A G E N D A

Architectural Review Board

September 25, 2018

541 Cloverdale Road

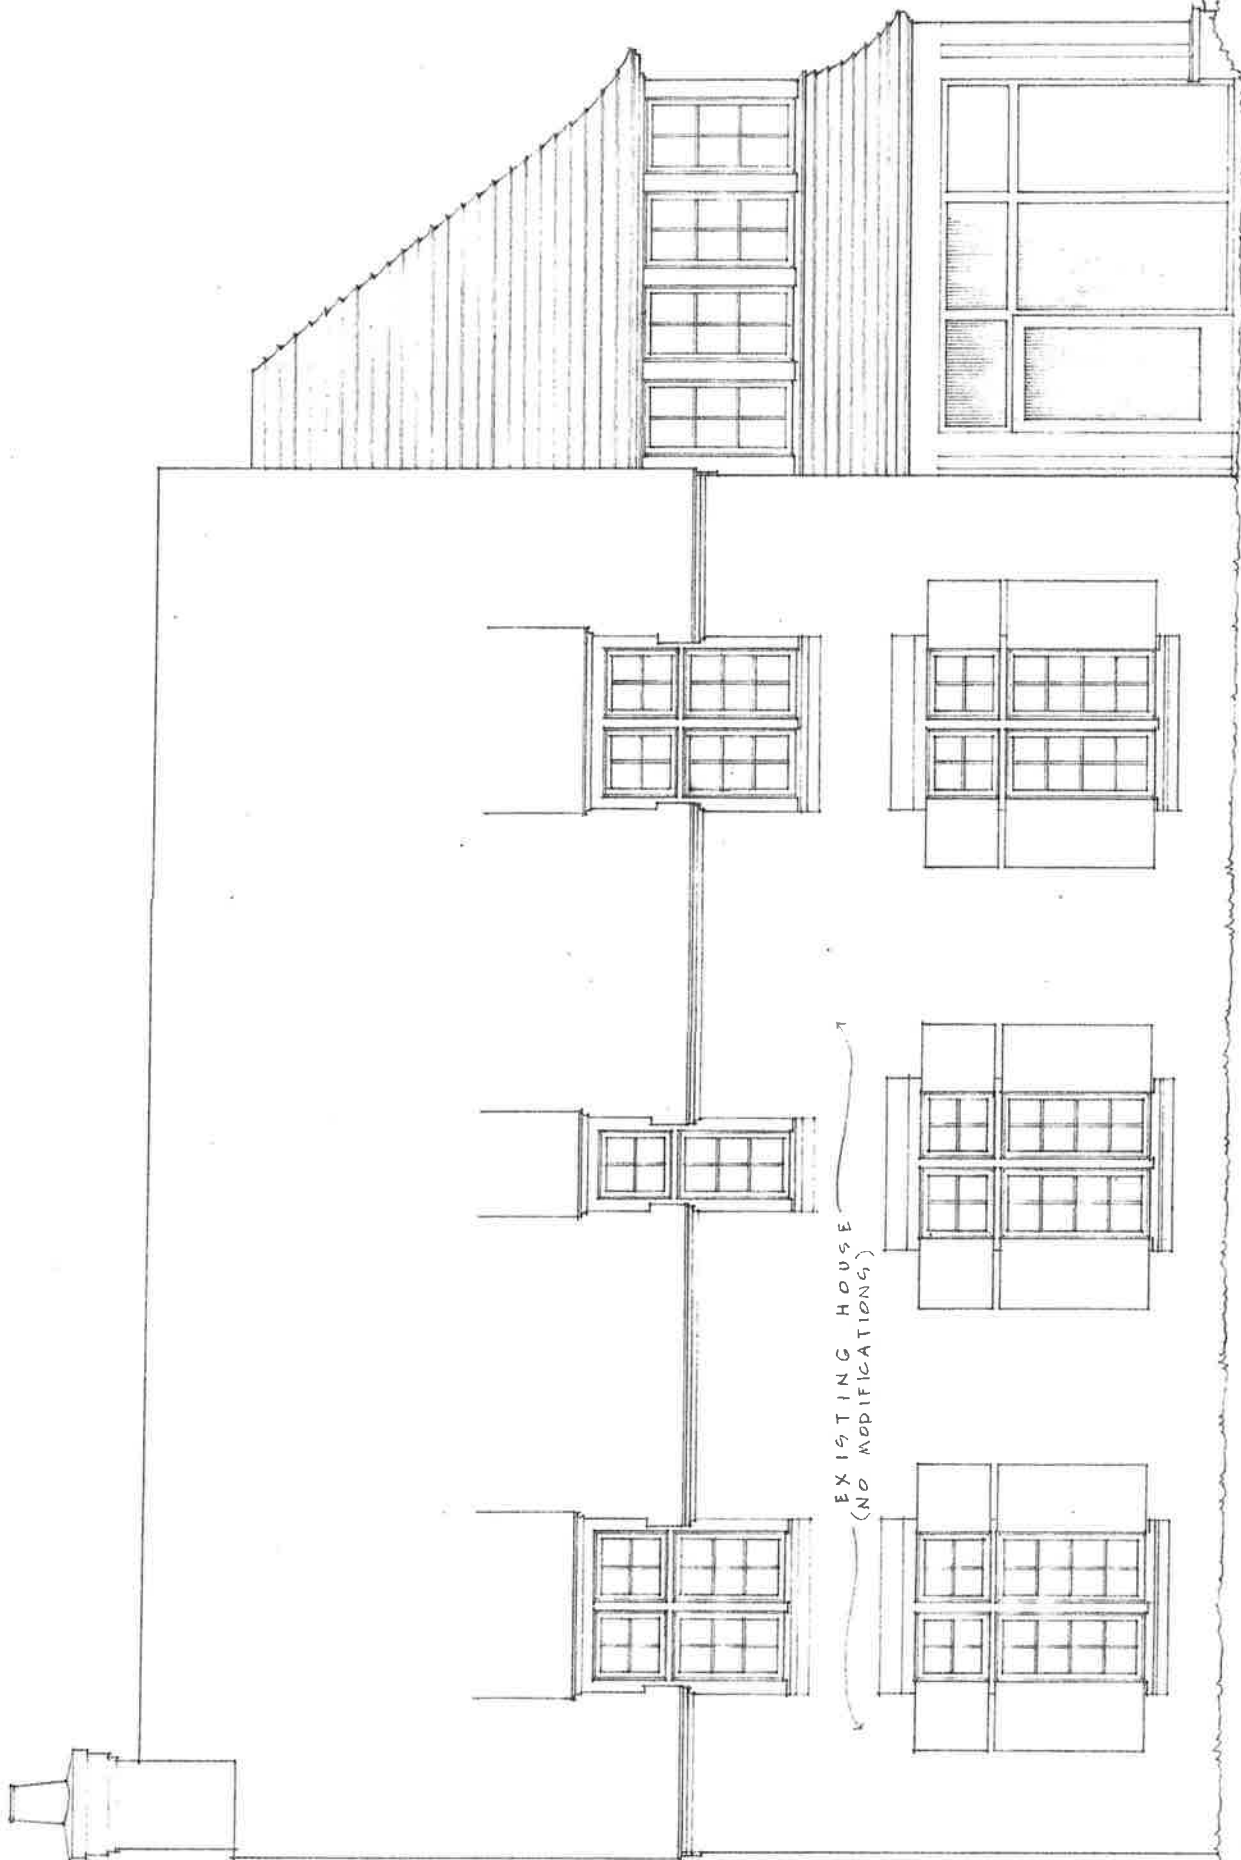
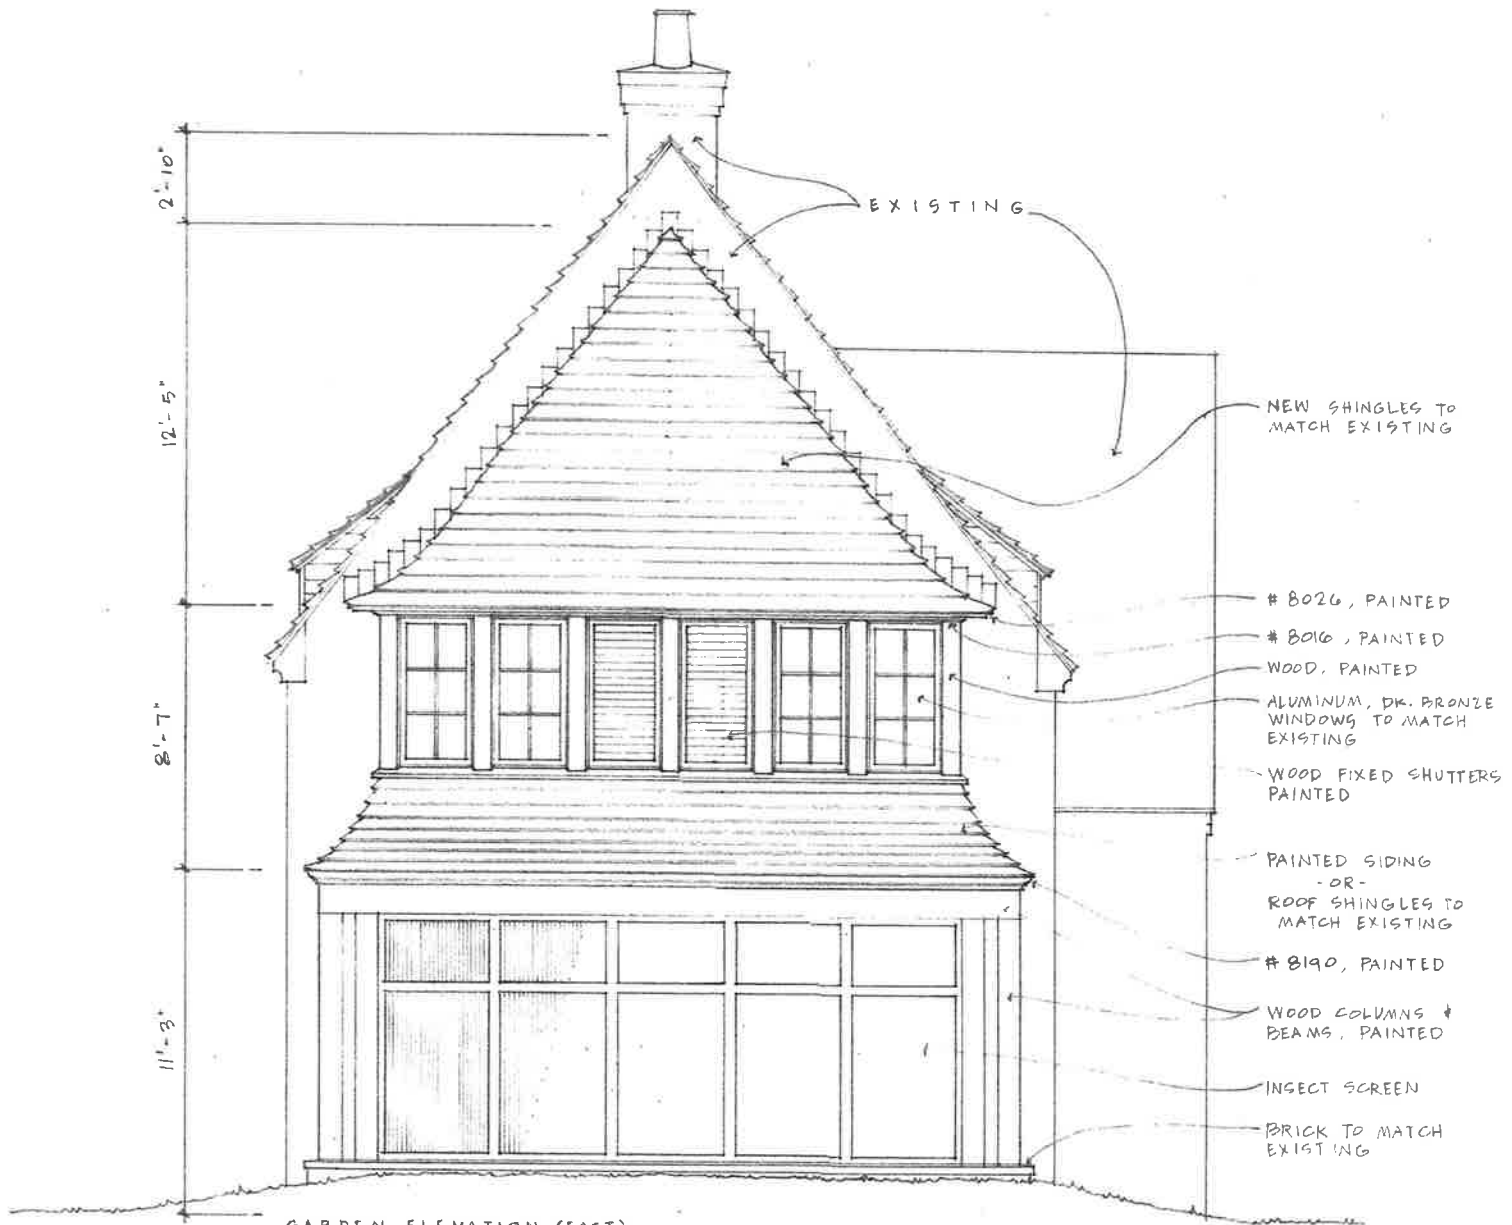
- ARB approved this plan as submitted in May 2017, that approval has expired.

622 Felder Avenue

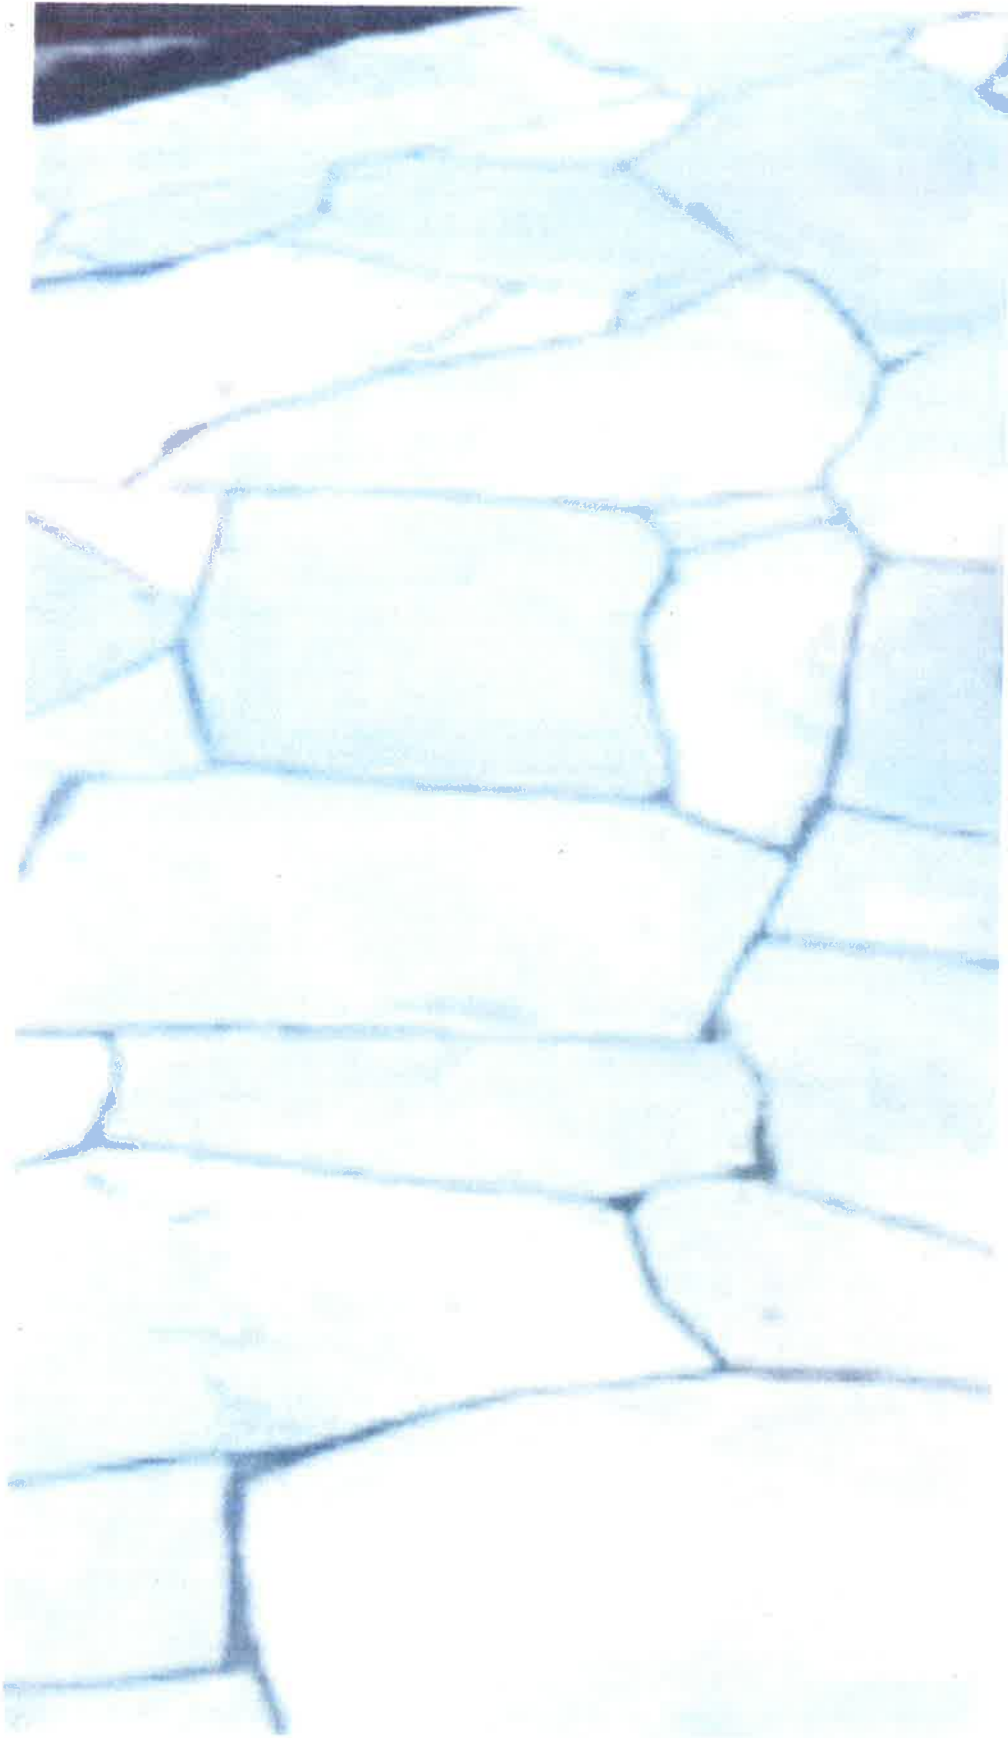
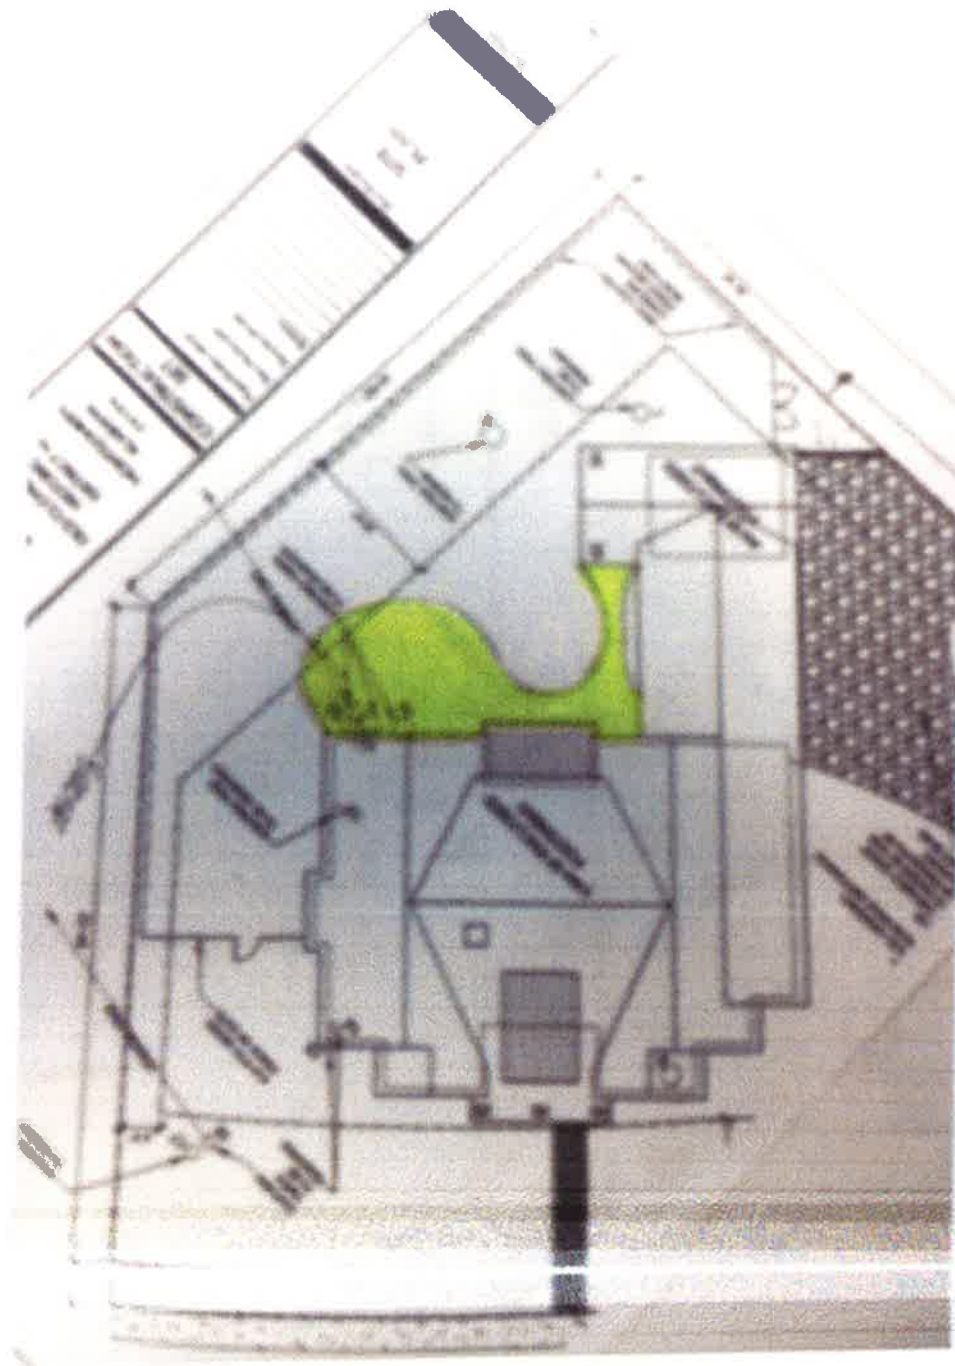
- No objection

115 Coosa Street

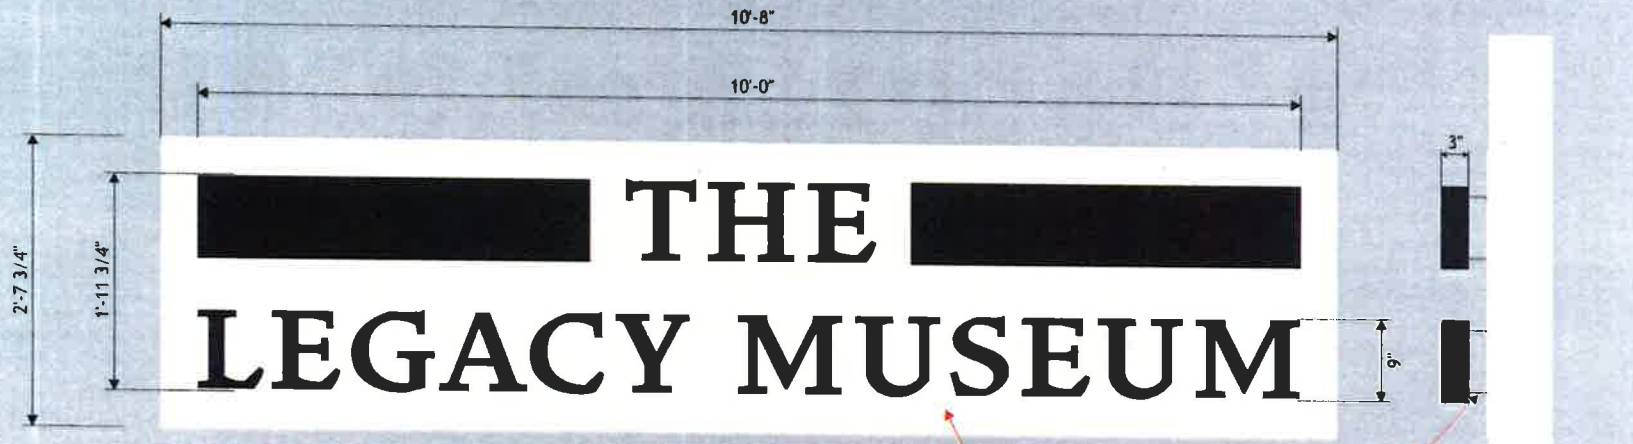
- Proposed signs should not exceed 20 square feet of surface area.
- The proposed sign is replacing a sign that was not reviewed or approved by the ARB, it was not part of the original submissions for alterations to the building.
